**CITY OF LA VISTA  
PLANNING DIVISION**

**RECOMMENDATION REPORT**

CASE NUMBER: 2015-CUP-02  
2015-PUD-04

RE: Comfort Suites Design Review #1

<b>DRAWN:</b> PROJECT NO.	
<b>TITLE:</b>	
<b>SITE DETAILS</b>	
<b>DWG FILE:</b>	
15000-Site Details	
<b>SHEET NO.:</b>

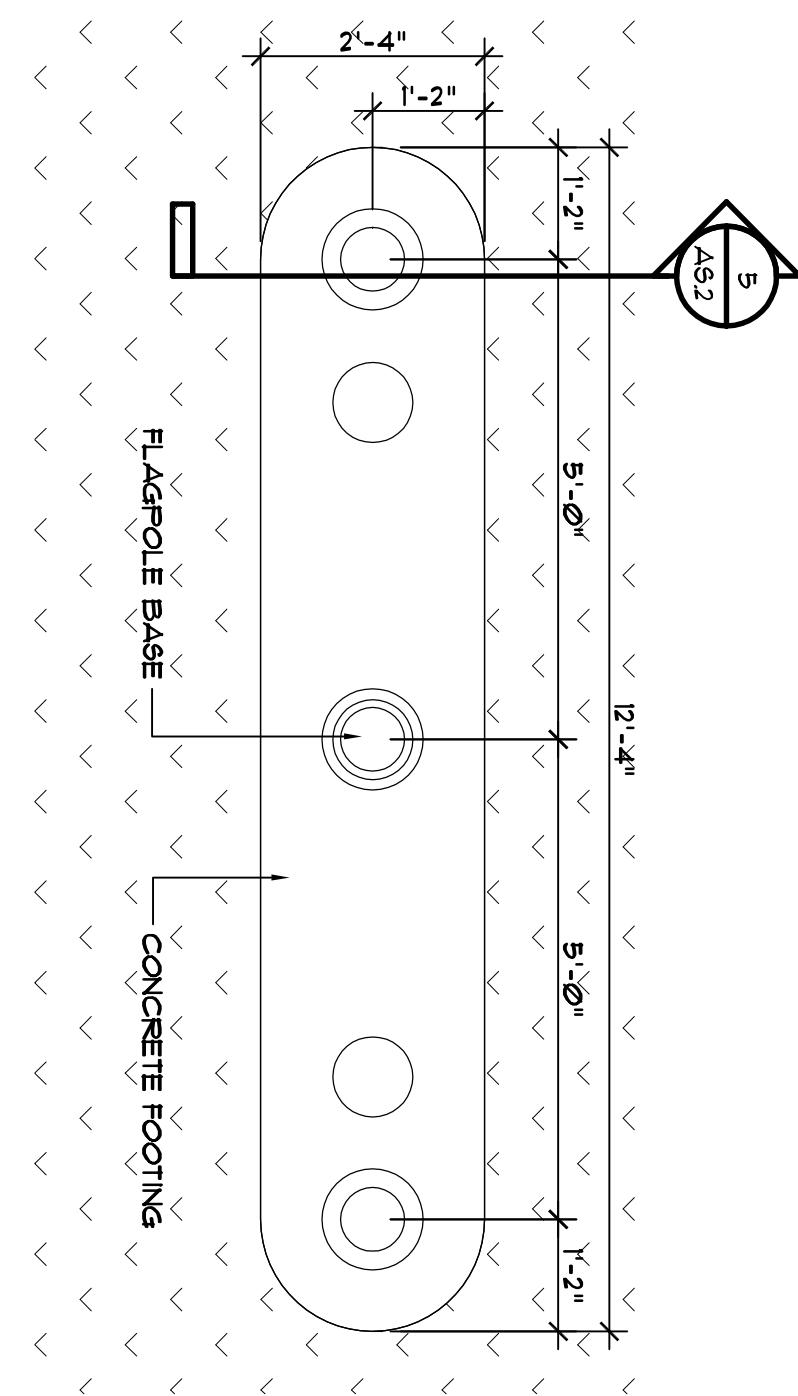
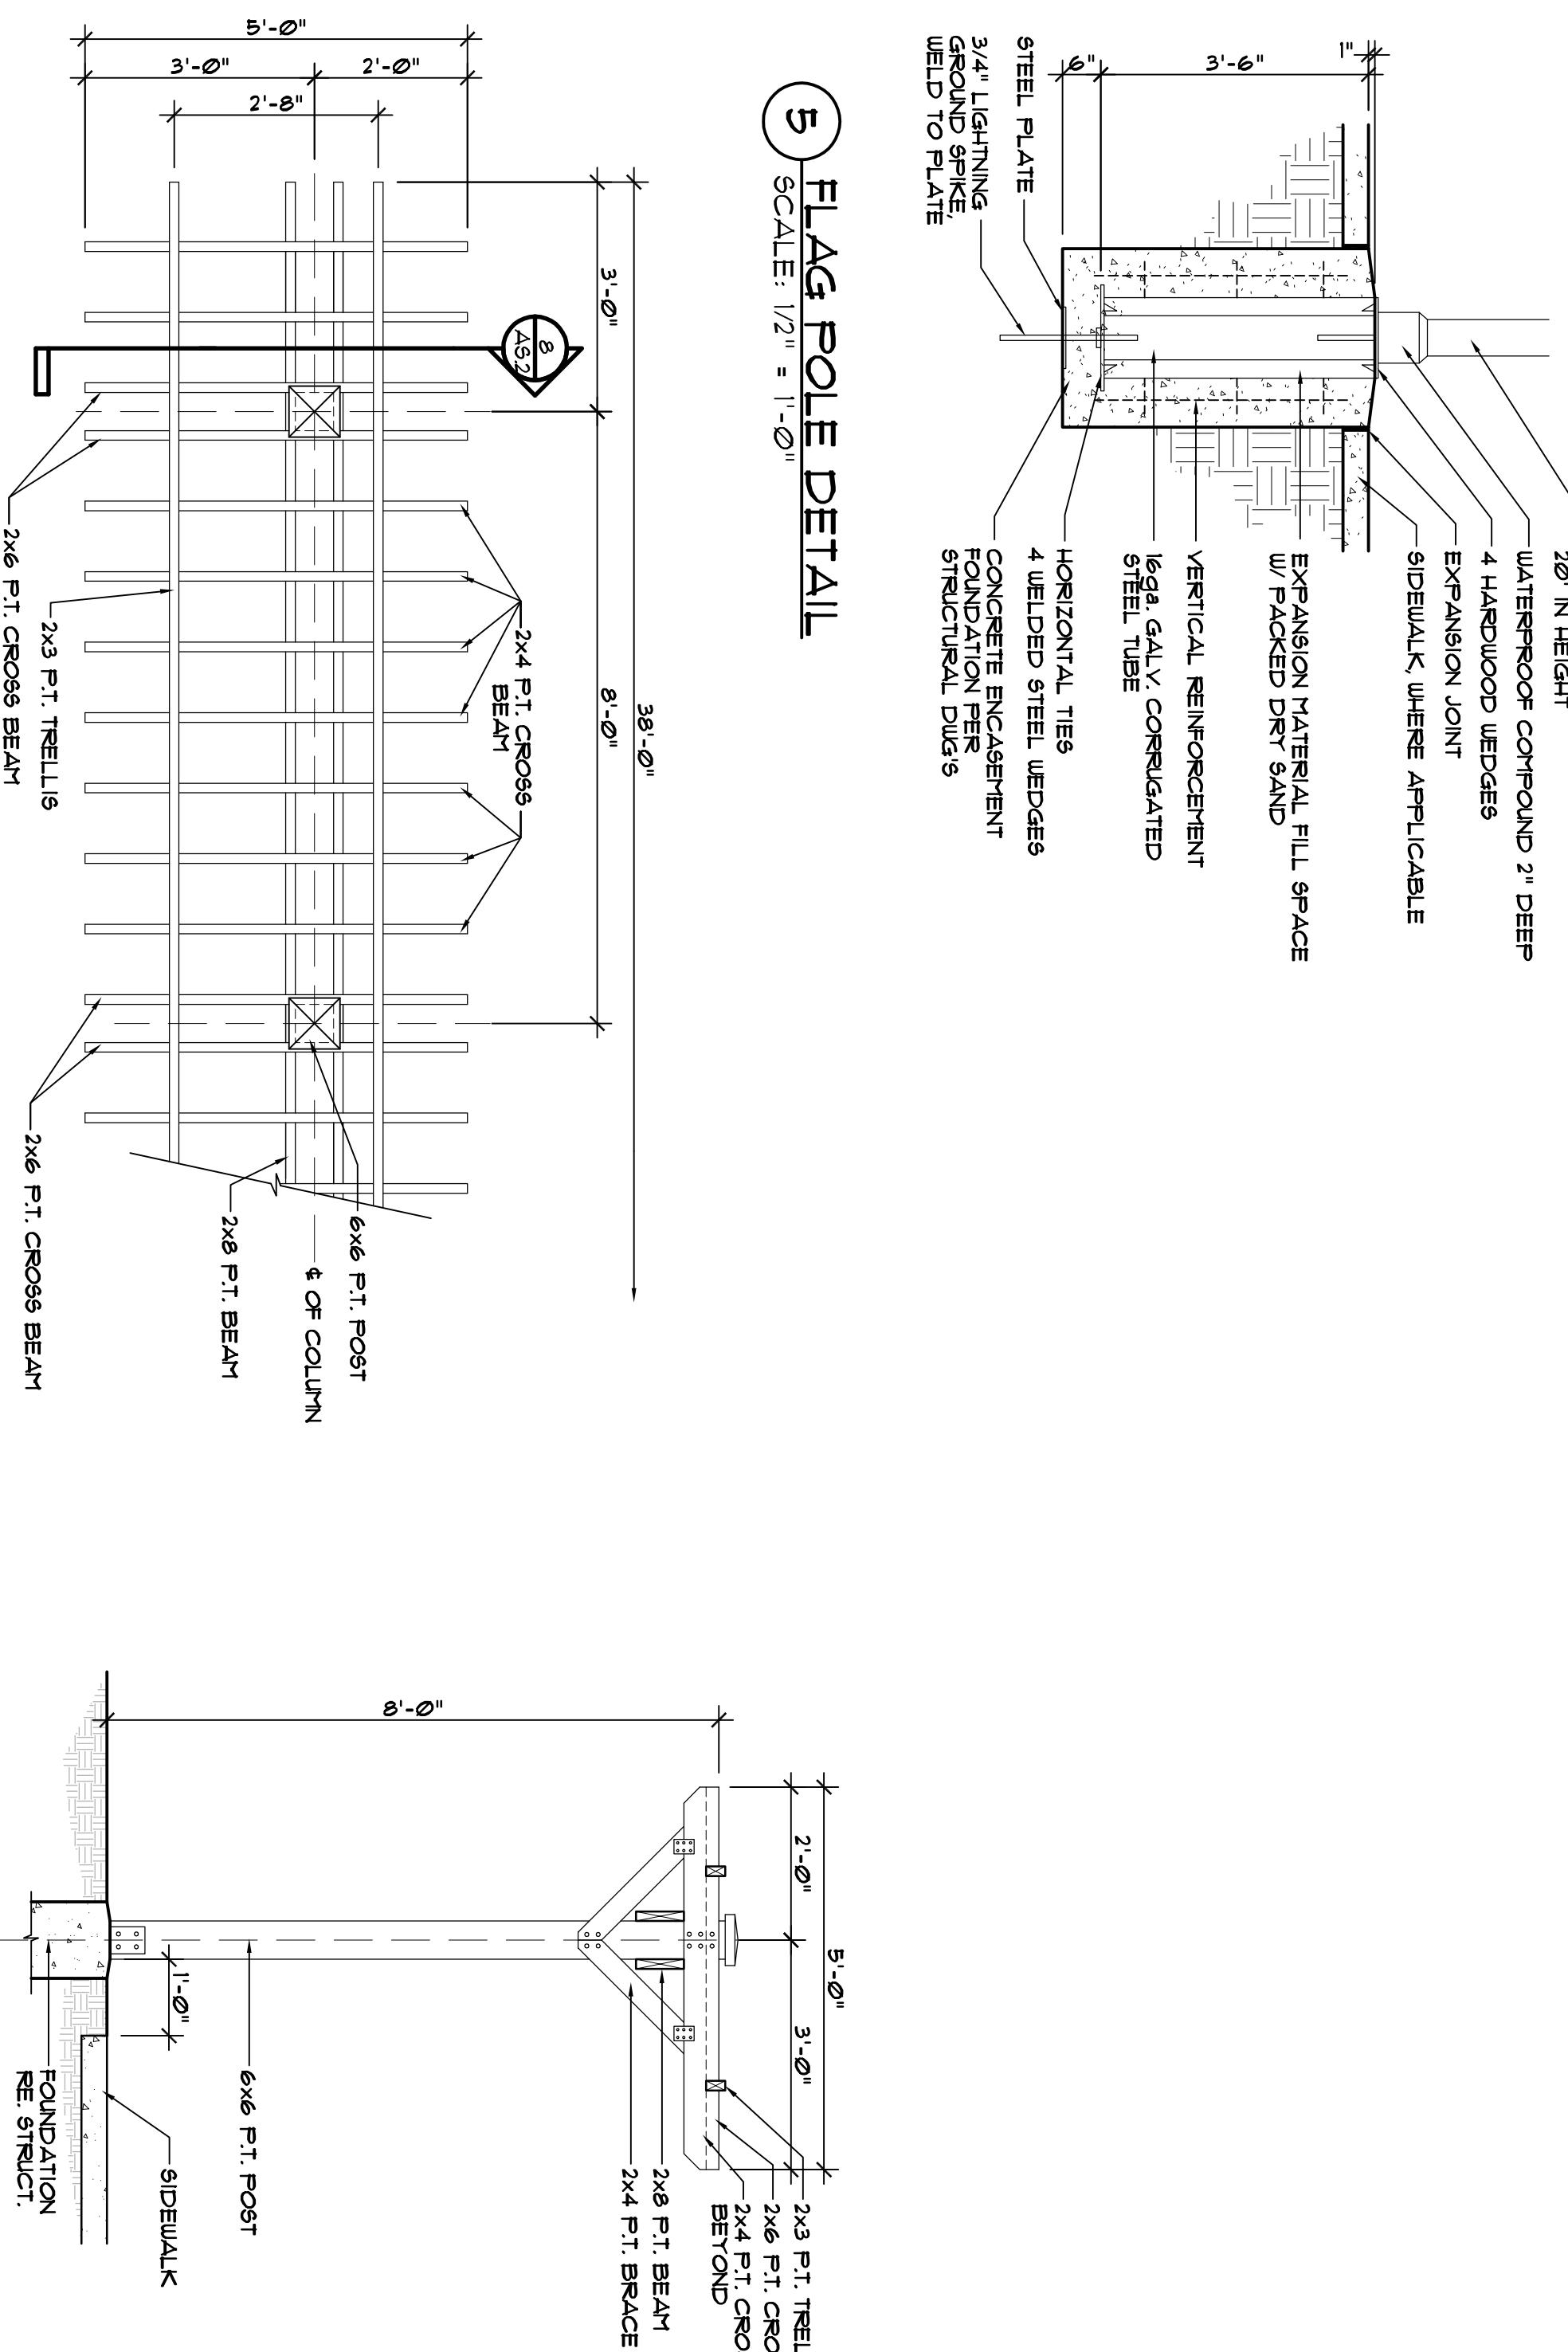
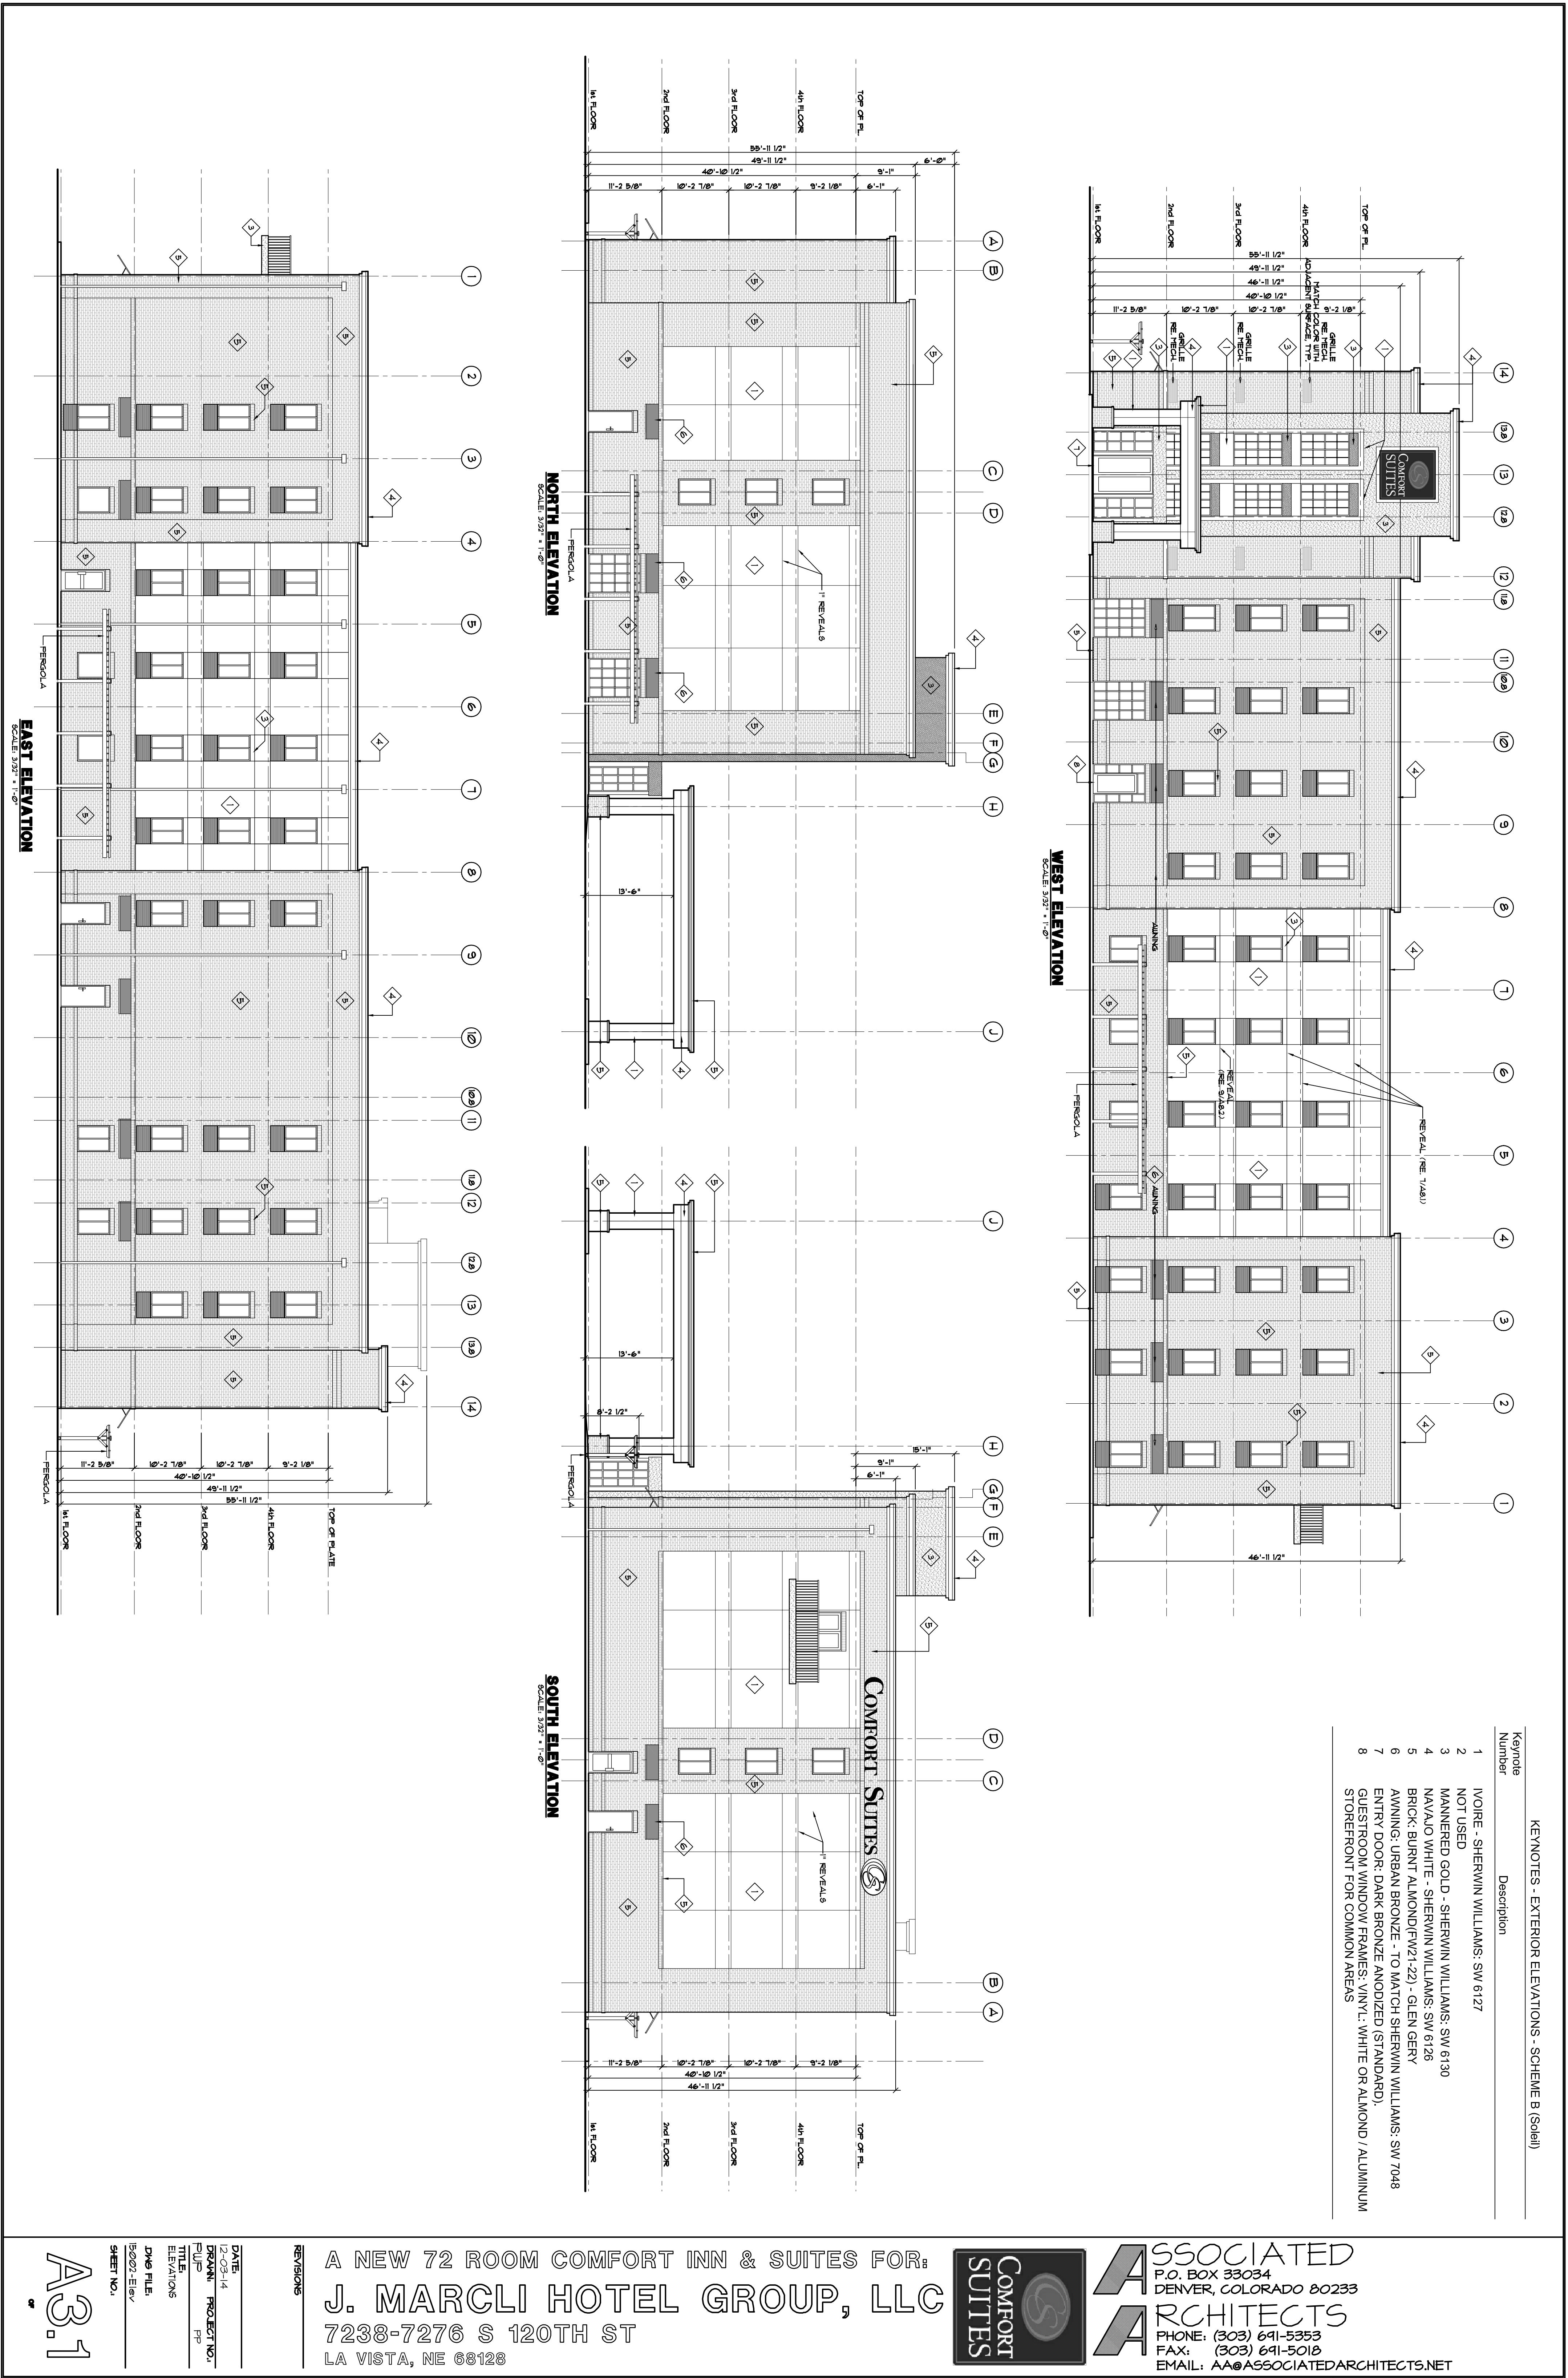
1. Detail 2 - the trash enclosure as submitted does not meet the requirements. (Refer to Appendix R. Refuse Screen Gate)
2. Detail 8, note 5 - submit physical sample of "redwood" stain specified for compliance with acceptable colors. (Refer to Appendix N. Minor Accent Color Ranges)
